Specification MOA/CV2416	SECURITY		
Issue 3, Dated 8th July, 1963	<u>Specification</u>	<u>Valve</u>	
To be read in conjunction with K1006	Unclassified	Unclassified

SPECIFICATION MOA/CV2416 ISSUE 3 DATED 8th JULY, 1963 AMENDMENT No.1

FIG.2
SHORT CIRCUIT INDICATOR

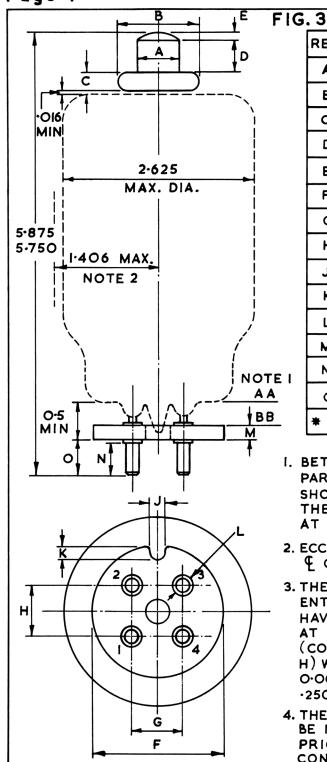
Page 5 Note 11

Amend penultimate sentence to read "Check for short circuits with an approved neon sensitive detector".
